SEWAGE DISPOSAL SYSTEM

MARYLAND STATE DEPARTMENT OF HEALTH

PROPERTY OWNER Clara R. Jackson

APPLICATION

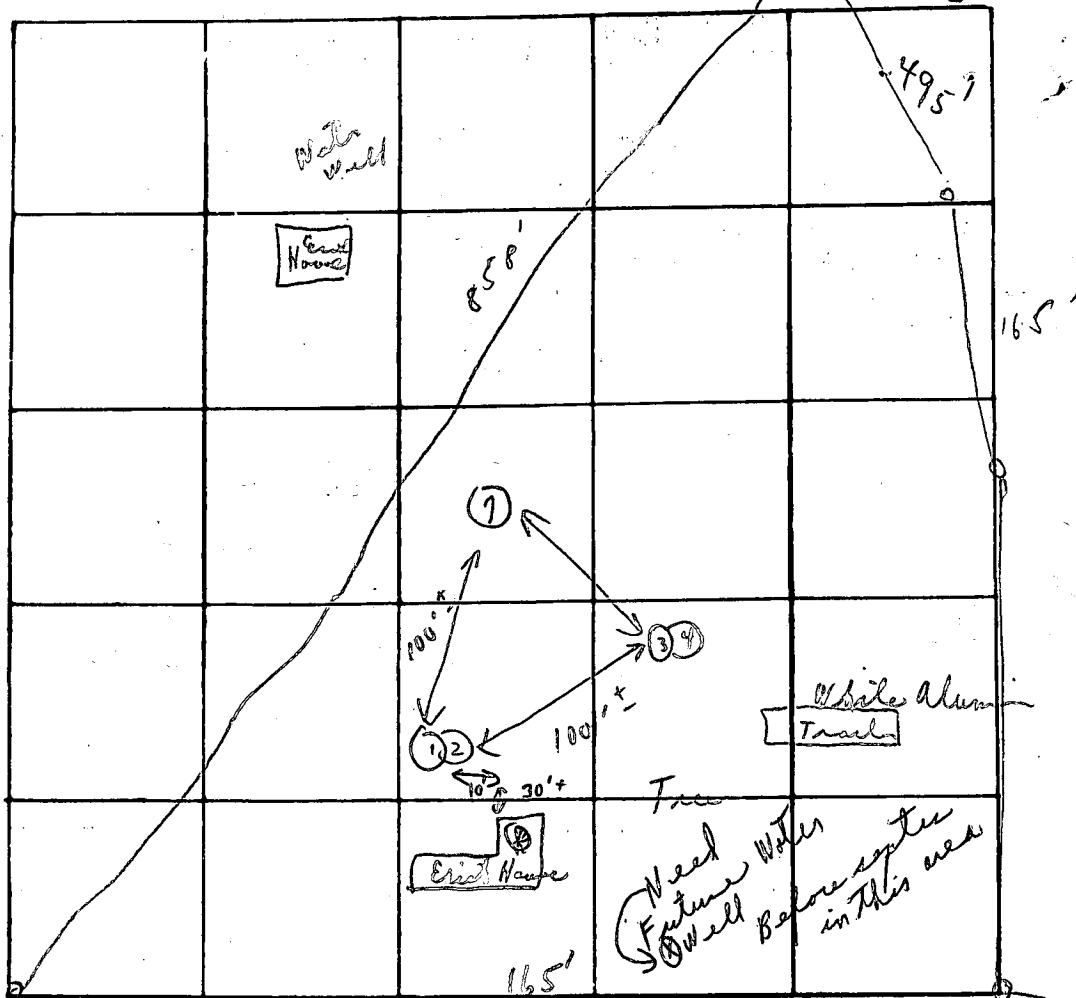
REASONS FOR REJECTION OR HOLDING 6/8/78 Existing house then note send memo
Hold per D.W.M. - 3 holes & only ok per No above No
if necessary
B.W.M. / p.m. - 6/8/78

per Mr. Fyock Mr. Monaghan says 3 holes 100' apart

REMARKS: Spoke to Mrs. Jackson Open lawn No plumb

Dry well to have 125 sq. ft. effective absorbant sidewall area per bedroom below inlet. Inlet to be 3 1/2' below original grade and maximum depth 11 1/2'. Location 30' from center rear of existing house approximately ~~and~~ when facing lot from Cemetery Road. (Pore hole [1+2])
